NEW YORK CITY DEPARTMENT OF CORRECTION
Cynthia Brann, Commissioner

ADDENDUM No. 5 to PIN: 072202001CPD
Powerhouse Boiler Feed Water Treatment System Upgrade

Pursuant to section §3-04 of the Procurement Policy Board (PPB Rules, the Department of Correction (DOC) is issuing Addendum No. 5 to the solicitation for the services referenced above.

Drawing No.:
T003.00

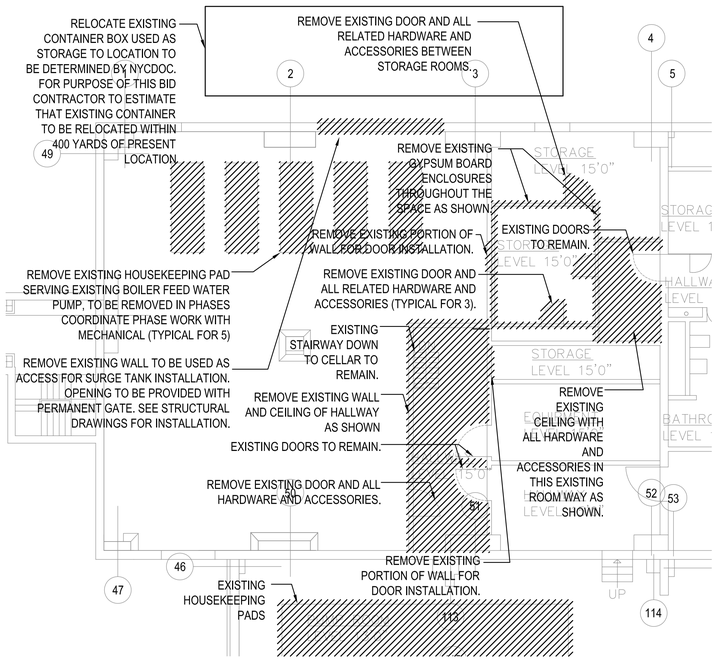
1) T003.00 – Added add alternate No.2 in scope of work.

100. Please refer to Drawing T003 and the Bid Form. Drawing T003 mentions Add Alternate #1 to provide new 4" boiler feed piping and connect to the existing boiler feed to co-gen plant but this is not addressed on the bid form / schedule of prices. Please clarify.

Drawing No.:
A101.00

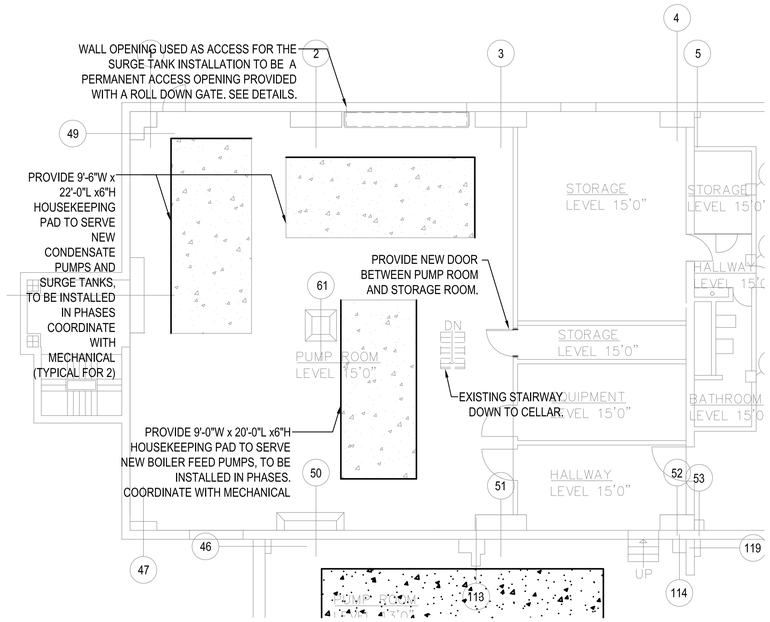
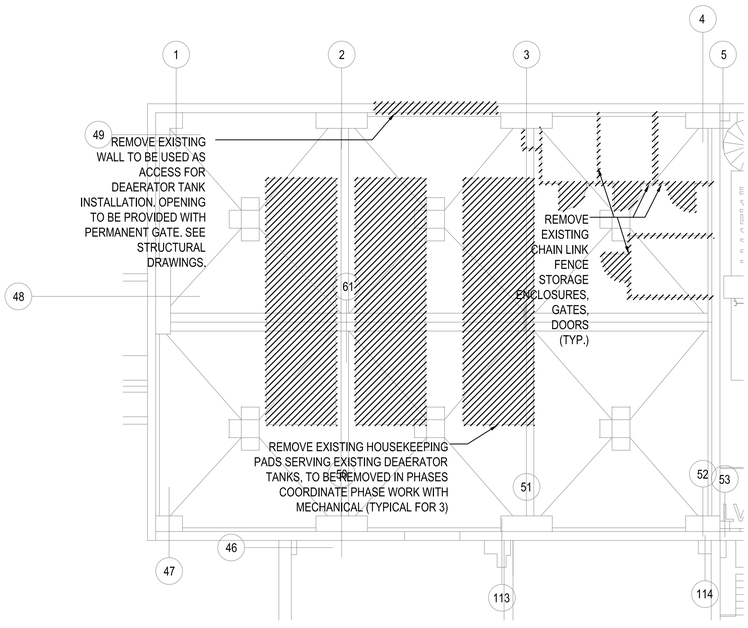
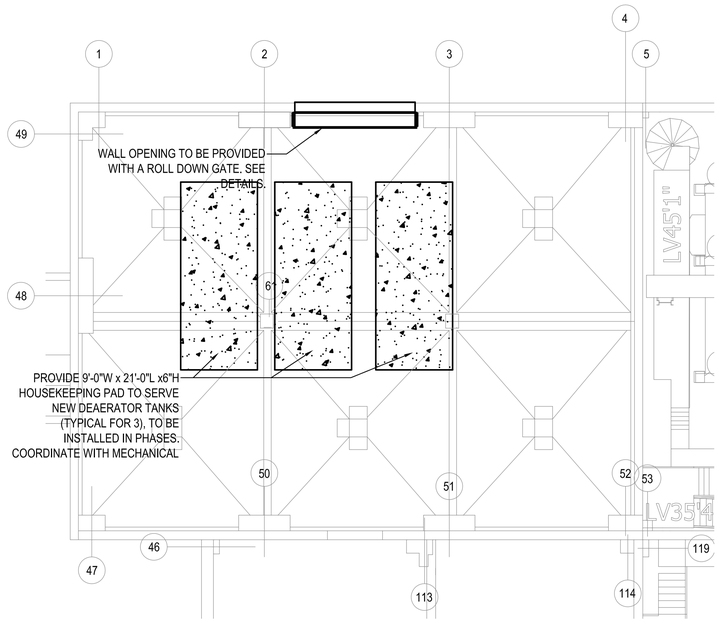
2) A101.00 – Revised floor plan.

Response: As shown on drawing A-101, Part Plan 3 "Deaerator Room Floor Plan – Demolition", the existing Container Box used as storage shall be relocated by contractor within 400 yards of its present location with NYCDOC determining its new location. The container box as shown is revised in addendum to show on Part Plan 1 "Pump Room Floor Plan Demolition.

93. Please refer to Drawing A-101 and the Mechanical Phasing Drawings. The drawings show the removal of the existing exterior wall at both the pump room and deaerator room to facilitate construction and for the new roll up door. Please verify that this the only location where the contractor is to alter the structure to provide access to the powerhouse and any additional access openings will be treated as a change condition?

99. Please refer to Architectural Drawings A-101 and A-102. Detail 4/A-101 states that the wall opening at the deaerator room is to have a roll down gate. Section Detail 4/A-102, however, shows the roll down gate only extending to the ceiling of the pump room and the area above to receive new CMU to close the opening at the deaerator room. Please verify if there is to be only one (1) roll down gate and Section Detail 4/A-102 is correct.

101. Please refer to Details 1 & 2 on Drawing A-101. The detail shows the installation of two new interior doors in existing walls but there is no door specification with the detailed specs. Please provide.

Response: Please see architectural drawings for full scope. The scope includes removal of exterior wall to the Pump Room (Level 15'00") and Deaerator Room (Level 35'4"), provision of roll up doors at both locations, removal of existing partitions in Storage, provision of new door in that room wall, etc.as shown in A-101.00. See addendum#5 drawing for additional scope.

Response: Details and specification of two (2) new doors in existing walls is provided on drawing A-101. See addendum#5 drawings for clarification.

Drawing No.:
M005.00

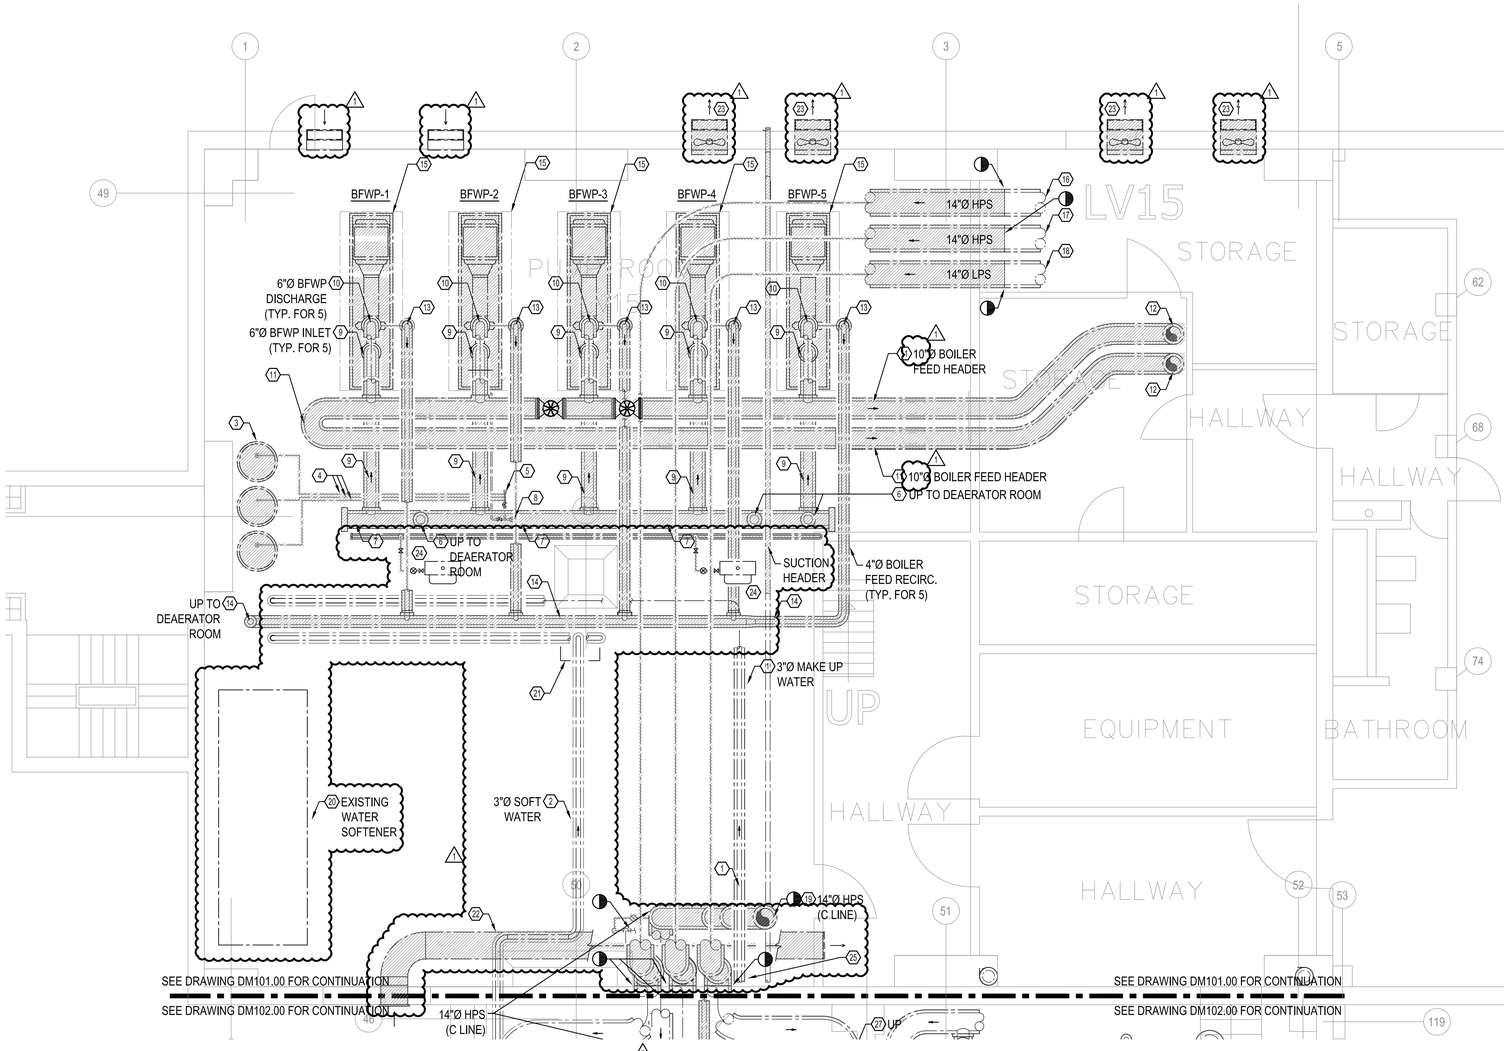
5) M-005.00 – Revised pump schedule. Added exhaust fan schedule.

44. Drawing M005.00 calls out six (6) boiler feedwater pumps (75HP, 460VAC), and six (6) condensate pumps (20HP 460VAC). It also calls out isolation valves but does not call out type or brand.

45. Drawing M005.00 also calls out a total of forty (40) Vanessa steam shut off valves but I did not find the source of control for these valves. Are these valves controlled by a Plant Master or Boiler control not shown?

Schedule on M005.00 calls for pneumatic Fisher Controls valves. Please clarify the required pressure reducing valve type.

Drawing No.:
DM101.00

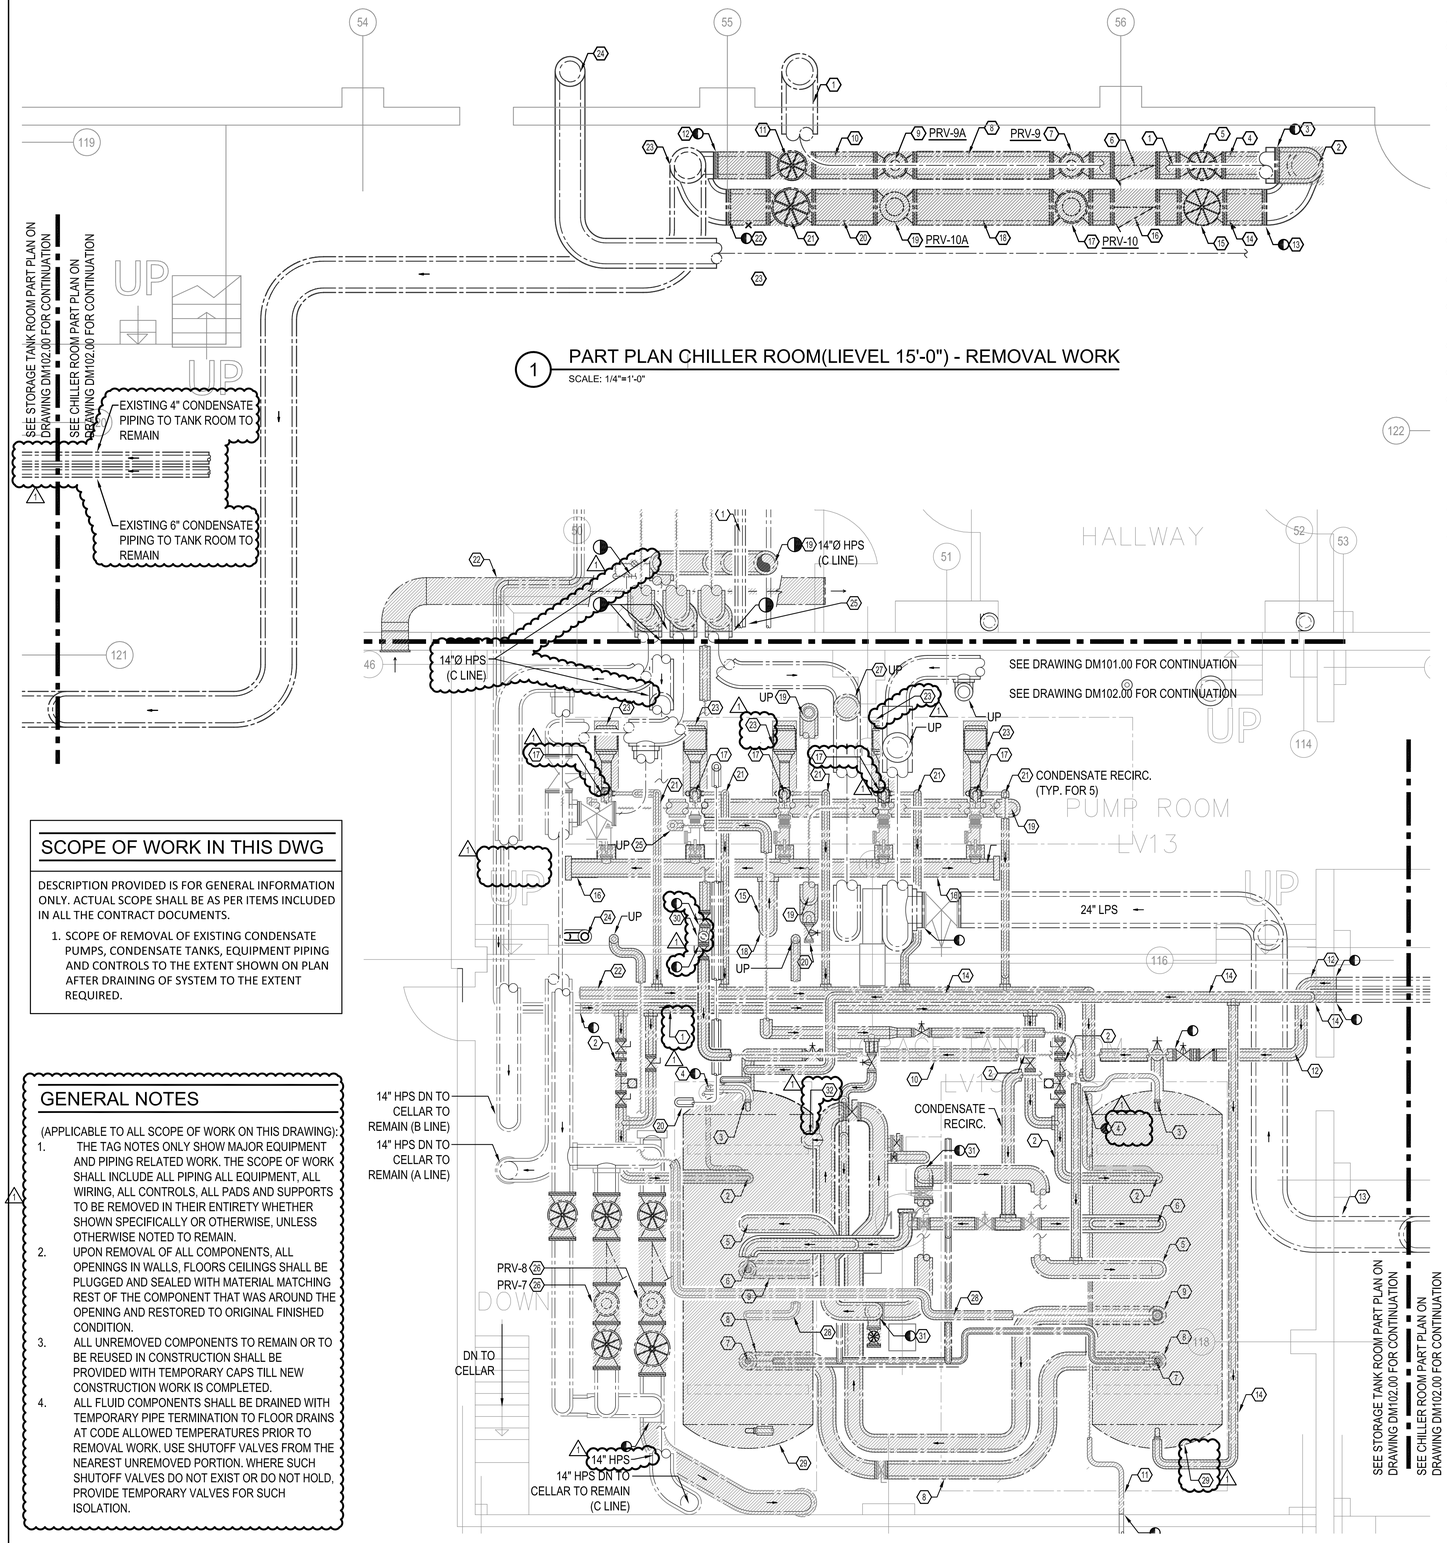
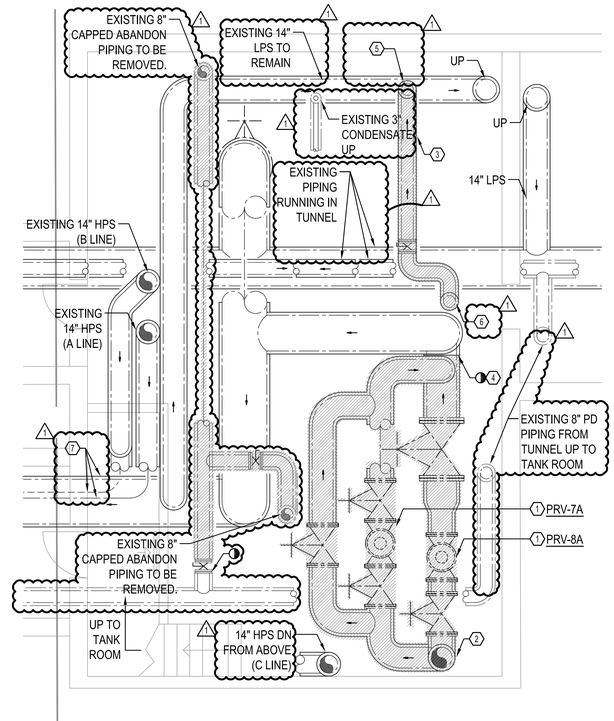
6) DM101.00 – Included removal of exhaust fans and ductwork, included location of existing water softener and existing booster pump.

Drawing No.:
DM102.00

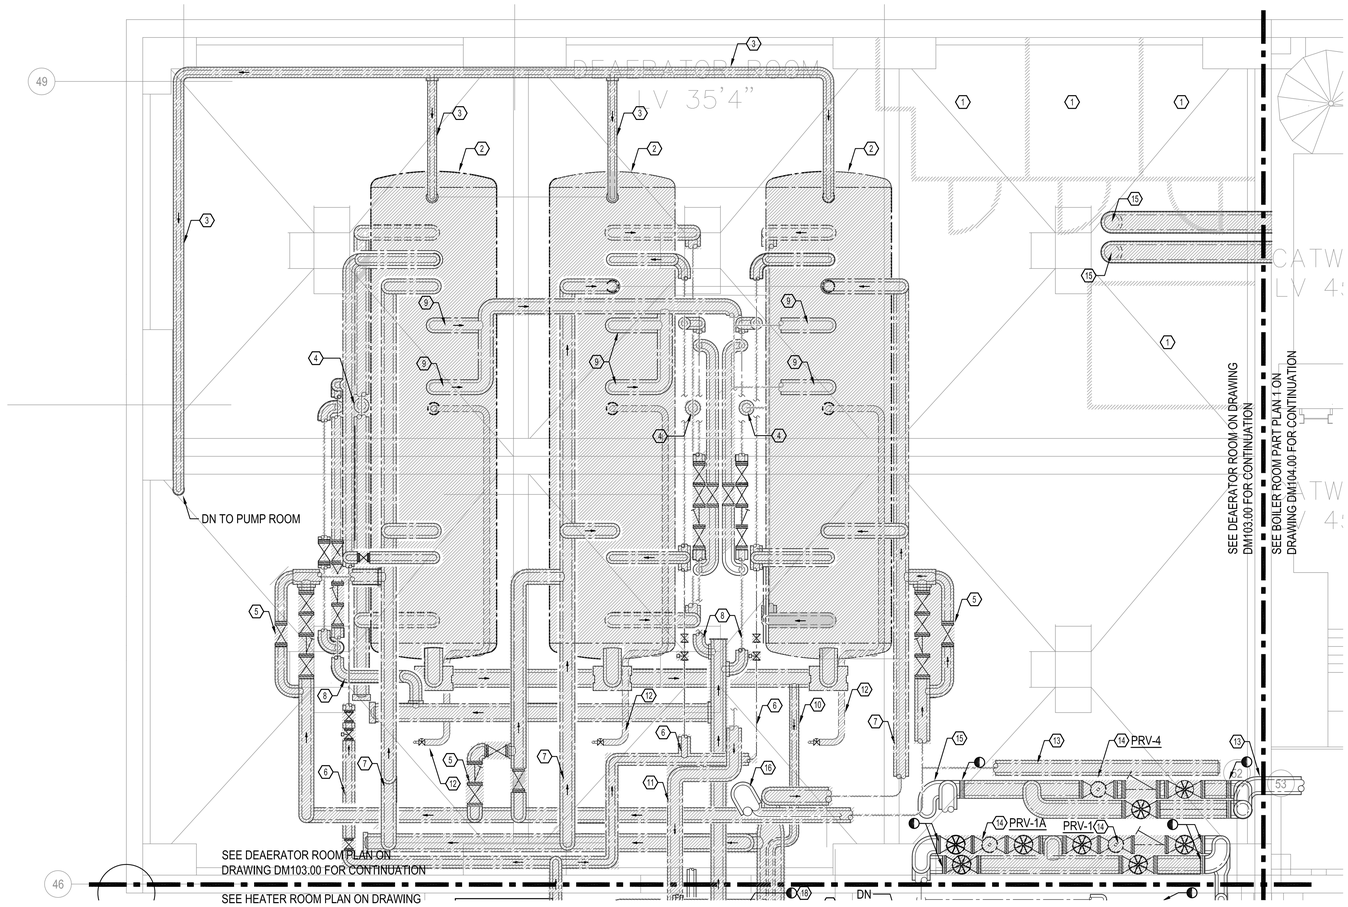
7) DM102.00 – Revised part plan tag room removal tag note number 30 and HPC work.

Drawing No.: DM103.00

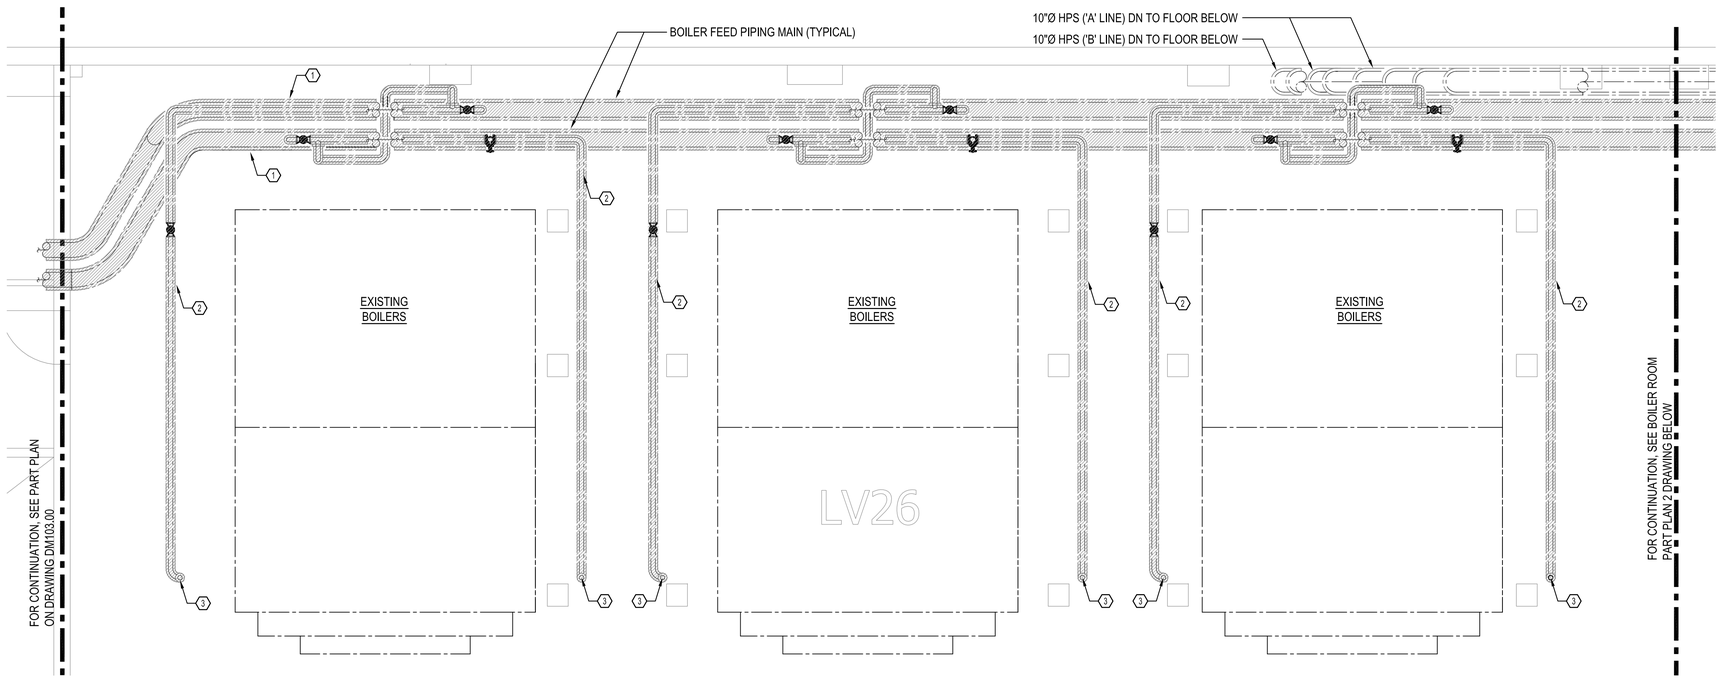
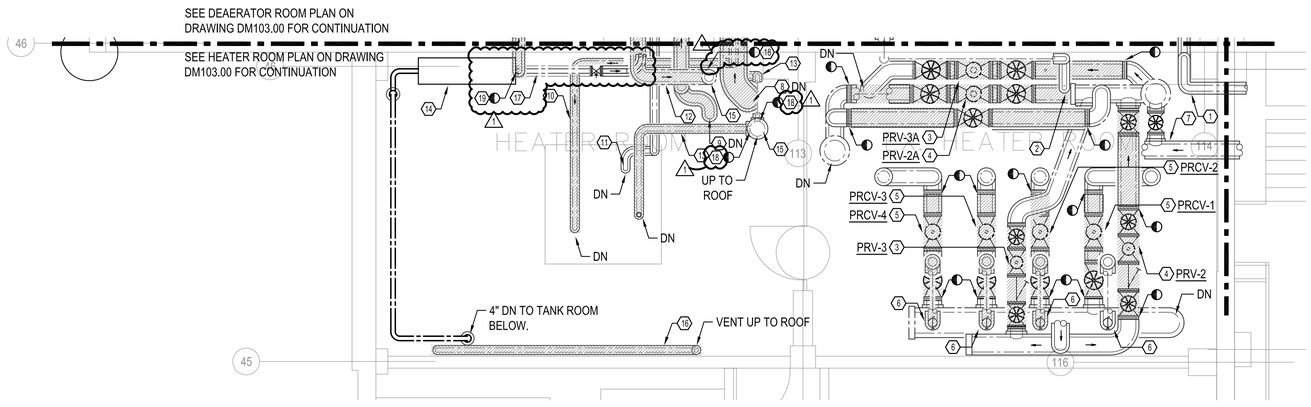
8) DM103.00 – Revised part plan heater room removal work tag note #17. Revised plan to show existing city make up water to remain.

Drawing No.:
M201.00

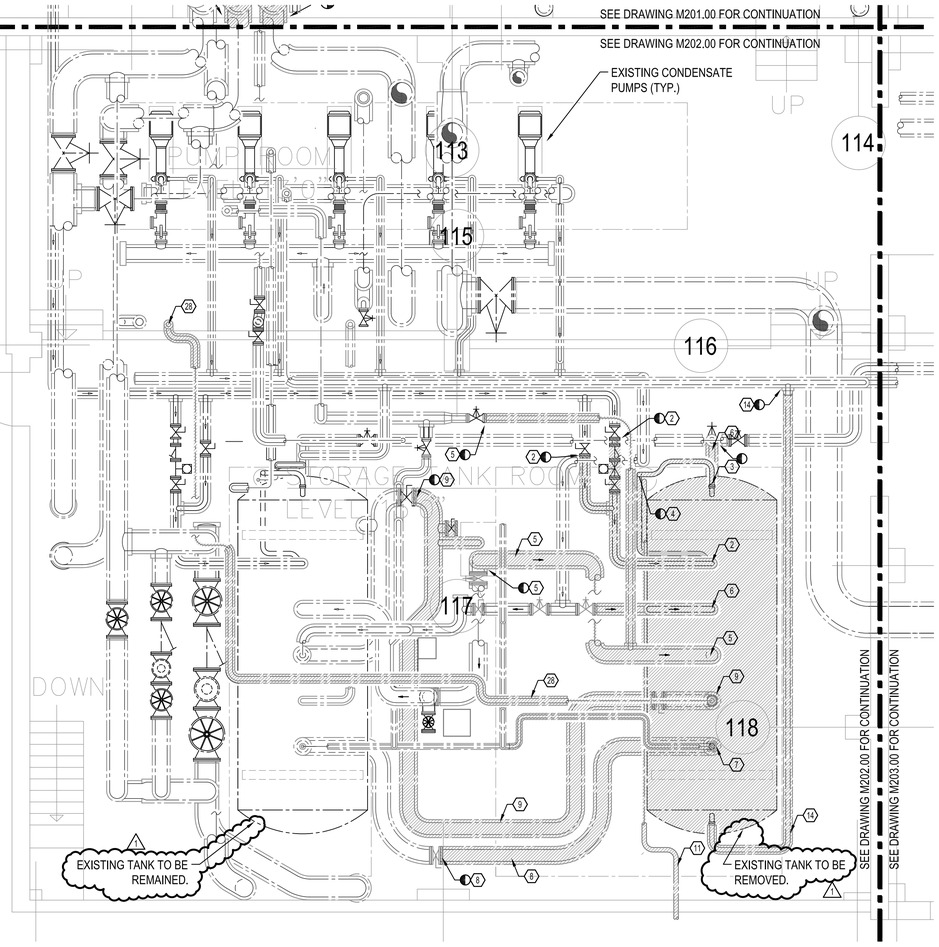
11) M201.00 – Revised tag notes and included existing water softener and pump.

33. Drawing M-402 shows 4" boiler feed discharge and a 10" boiler feed suction however drawing M-201 indicates a 6" boiler feed discharge (tag #24) and 6" boiler feed suction (tag #21). Also drawing M-201 (tag #22) indicates a 6" suction manifold, which cannot be correct. Please revise the drawings and coordinate the desired sizes.
